TVA-WBN-TS-00-06

WATTS BAR NUCLEAR PLANT (WBN) UNIT 1 - TECHNICAL SPECIFICATION  
(TS) CHANGE NO. 00-06 - INCREASE UNIT 1 REACTOR POWER TO 3459 MWt  
- RESPONSE TO REQUESTS FOR ADDITIONAL INFORMATION (TAC NO.  
MA9152)

### WATTS BAR NUCLEAR PLANT (WBN) UNIT 1 RESPONSE TO NRC REQUEST FOR ADDITIONAL INFORMATION

#### TECHNICAL SPECIFICATION CHANGE TS-00-06

# T-Hot to Degradation Rate Relation

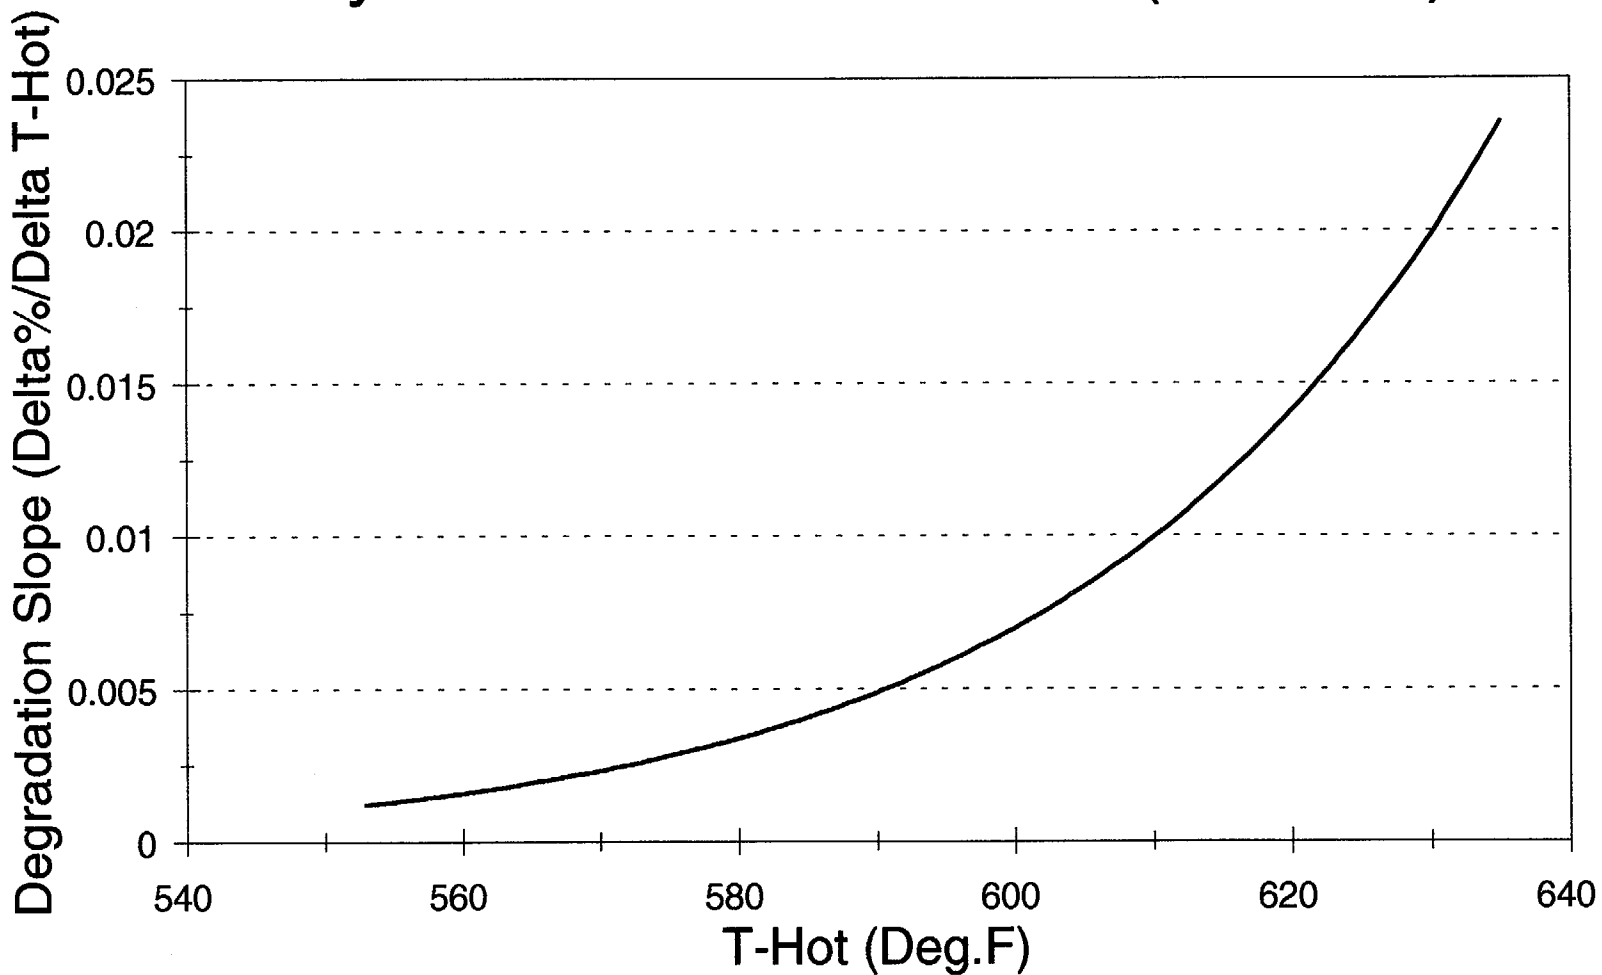
Section 5.6.5 - TVA stated that "...  $T_{hot}$  is expected to increase by 0.4 degree F for the 1.4% uprate and is considered to be the most sensitive operating parameter with respect to corrosion. . . ." TVA also stated that "... these changes are expected to have an insignificant effect on the tube corrosion mechanisms since they are relatively minor and are comparable to the range of uncertainties used in assessing corrosion. . . ." (1) TVA should expand on why the increase in  $T_{hot}$  is the most sensitive operating parameter with respect to corrosion. (2) If the increase in  $T_{hot}$  is within the range of uncertainties used in assessing corrosion and is relatively minor, TVA needs to describe the uncertainties in terms of quantitative or qualitative analysis to support the above statement.

- (1) Of the changes proposed in the 1.4% uprate, the minor change in temperature and the minor change in secondary pressure are the only changes that would affect corrosion rates. The  $T_{hot}$  change is considered to be the most sensitive to corrosion rates. The attached graph (T-Hot Degradation Rate Relation) represents industry data for Inconel 600 tubing. The graph illustrates the impact of temperature to corrosion rates, however, a 0.4 degree F increase affect can not be quantified. When assessing structural integrity of indications identified during an inspection, the change in the secondary pressure would be a sensitive parameter; however, as depicted in the two additional attached graphs, the change in  $\Delta P$  from 3876 psi to 3909 psi is also too small to be a quantifiable impact. The graphs illustrate structural limits for axial through wall cracking. One graph has the structural limit, the condition monitoring limit, and the end of cycle allowable limit with a  $\Delta P$  of 3876 and the second graph has the same limits with a  $\Delta P$  of 3909. The graphs illustrate the length of a through wall axial crack and its associated burst pressure. There is no difference in the acceptable length of a through wall crack at these two pressures.

### Axial Throughwall Crack, Target Pressure 3.876 ksi

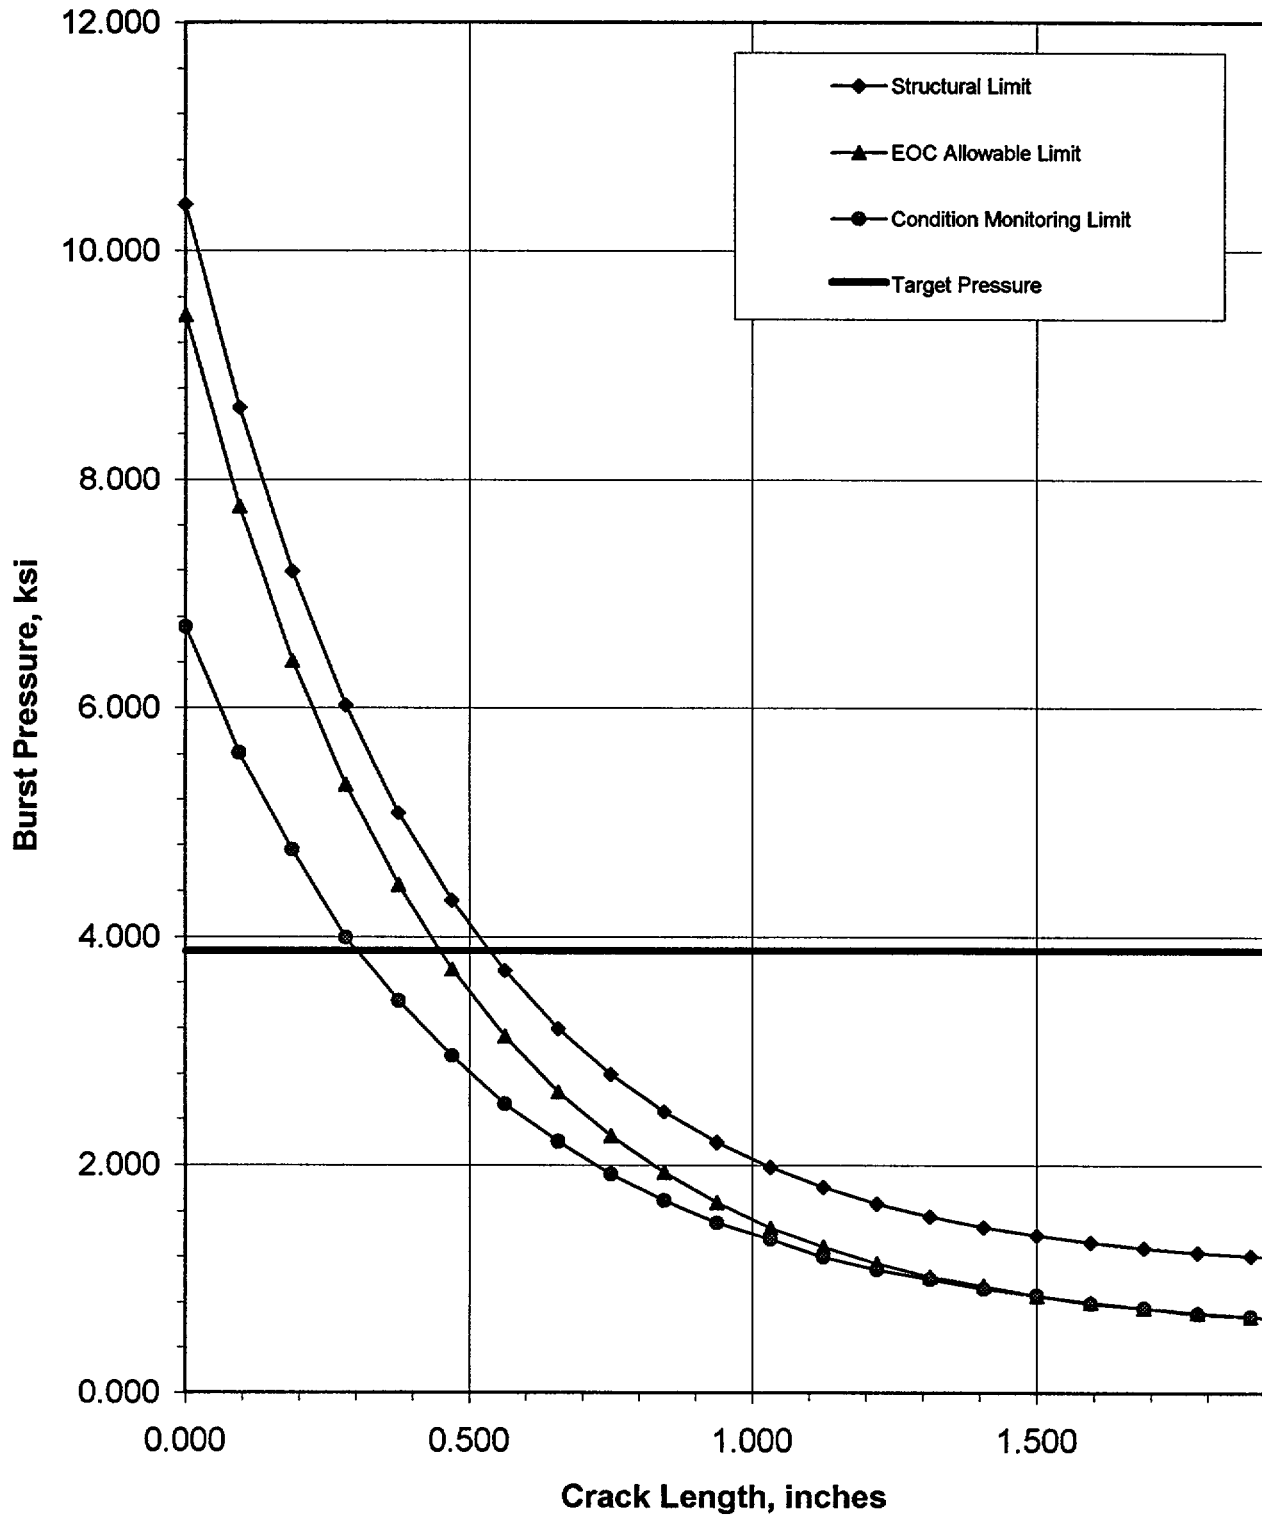
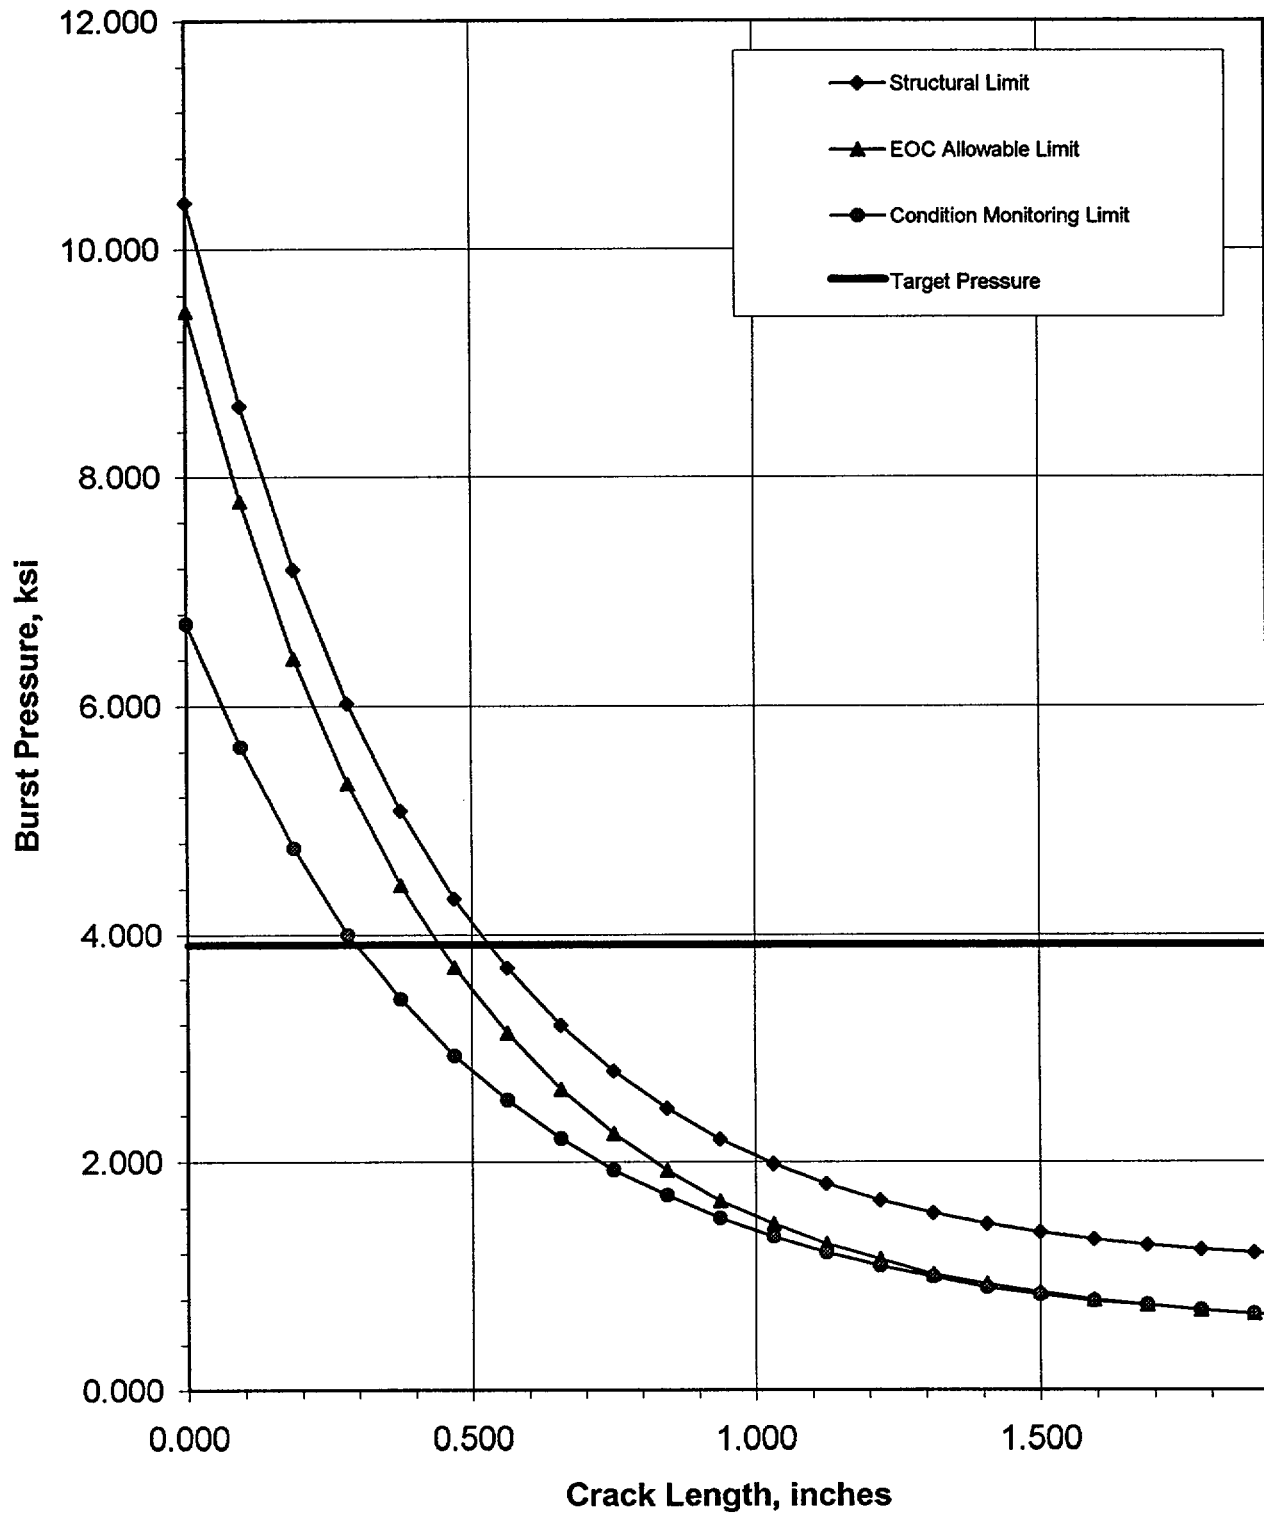
#### Question 4:

- (1) The attached graphs referenced in the response to Question 1 illustrate the structural limit for axial through wall cracks. These graphs demonstrate that there is no affect in the 11 psi decrease in secondary side pressure. Therefore, the requirements of RG-1.121 are still satisfied.
- (2) Tube inspections are driven by the degradation assessment. This uprate has not affected the degradation assessment; therefore, no changes will be made to the inspection plan for the upcoming outage. Future inspections will be determined by active degradation, potential degradation, industry experience, and plant-specific operating experience. If the temperature change affects degradation growth rates, the repair limit will be assessed during the operational assessment.

### Volumetric - 360 Degree Uniform Thinning at 3876 psi

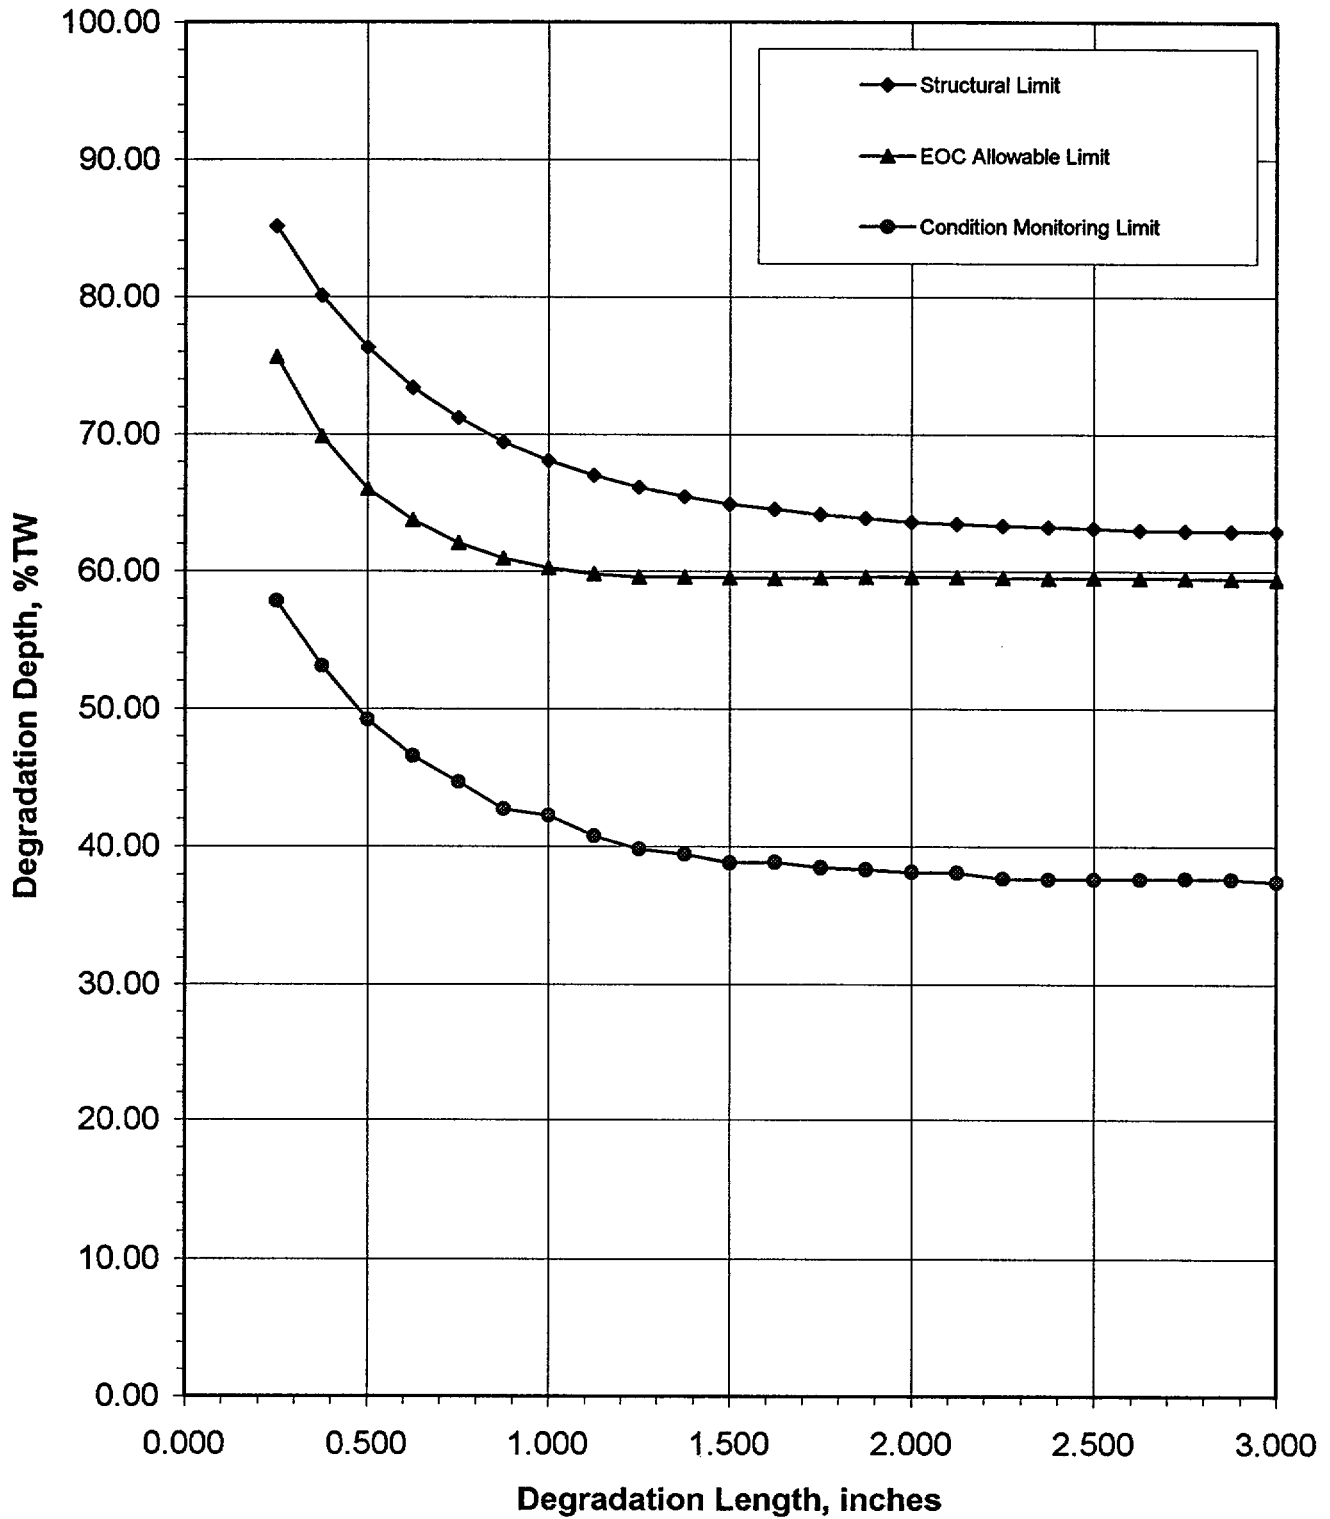
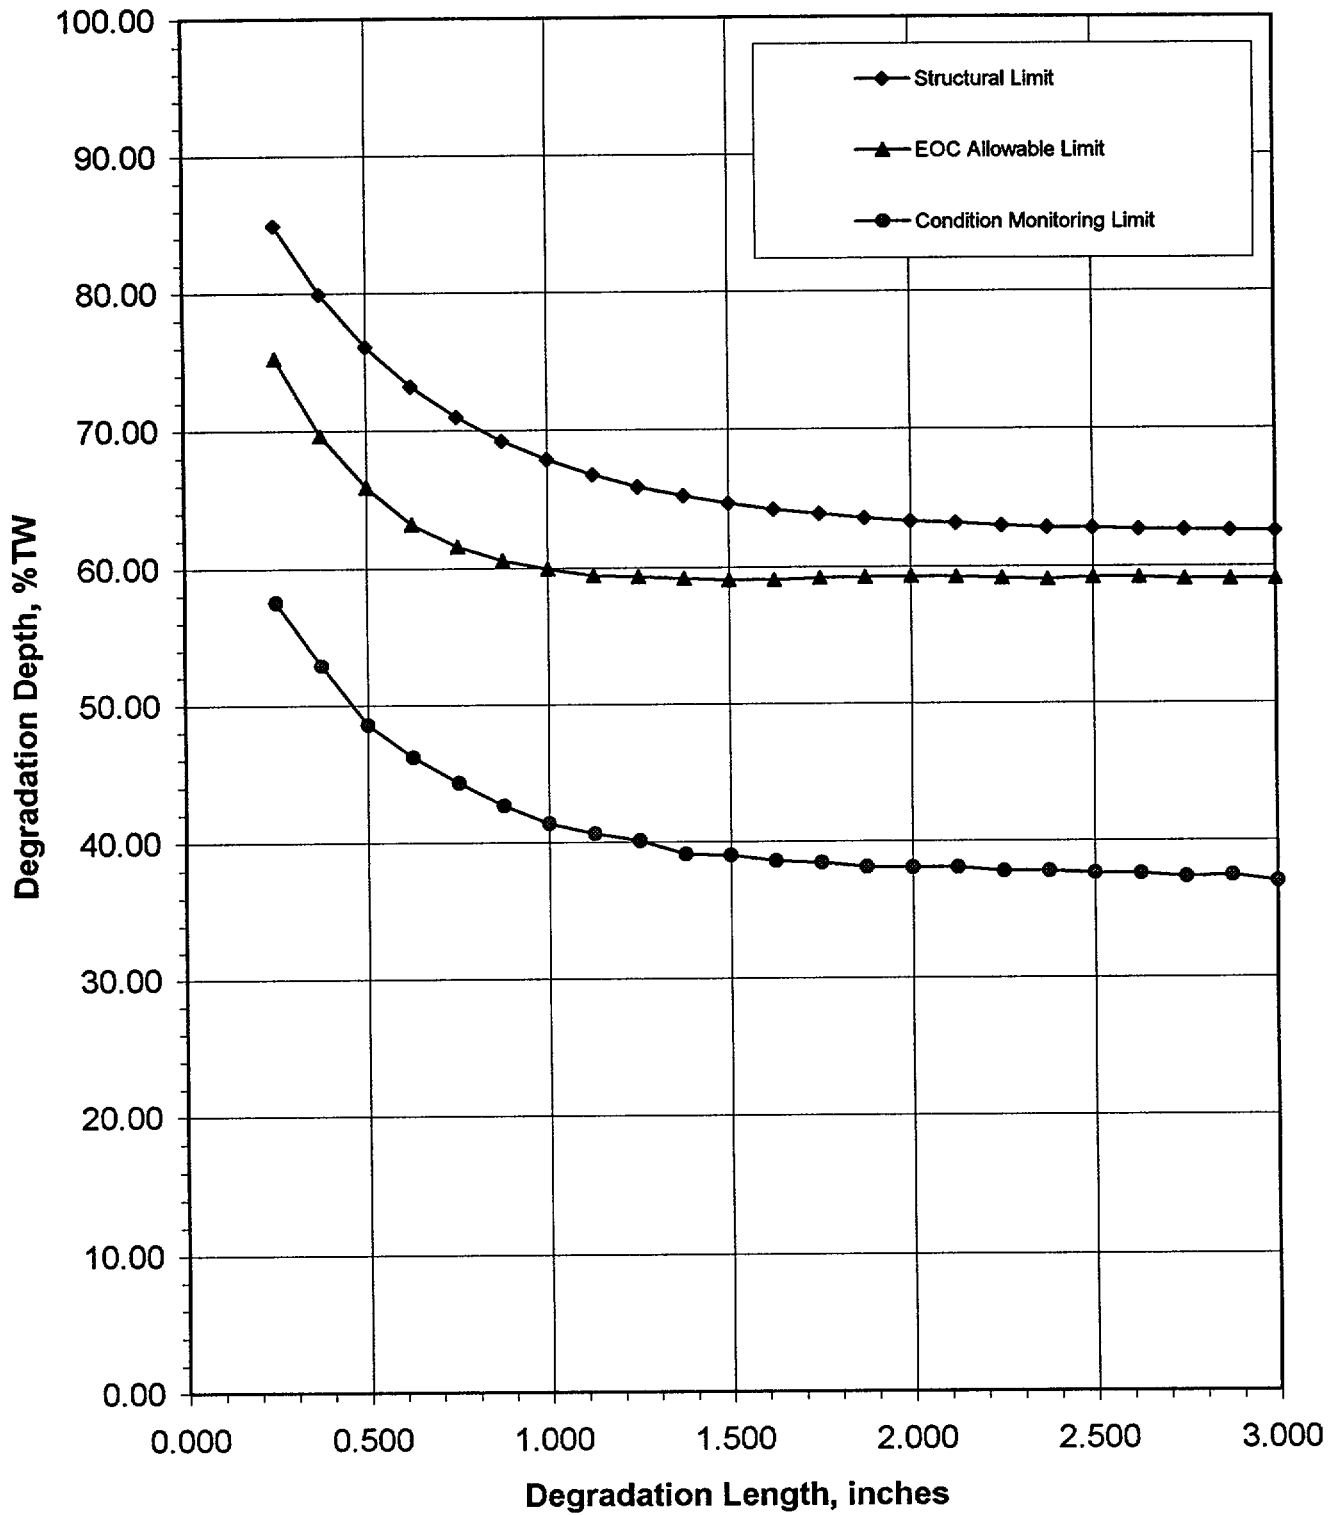
Section 5.6.6 - TVA performed a preliminary assessment to confirm that the existing 40% through wall plugging criteria will remain adequate for the power uprate condition. Provide the final assessments for staff review.

The only degradation at WBN that is left in service based upon the 40% repair criteria is thinning and wear. Both of these degradation types can be bound by uniform wall thinning calculations.

High temperature burst pressure data for steam generator tubing in NUREG/CR-0718 and NUREG/CR-2336 was used to develop burst pressure equations for steam generator tubing with various types of wall thinning. For a tube exhibiting uniform thinning over the full tube circumference, the average normalized burst pressure is represented by:
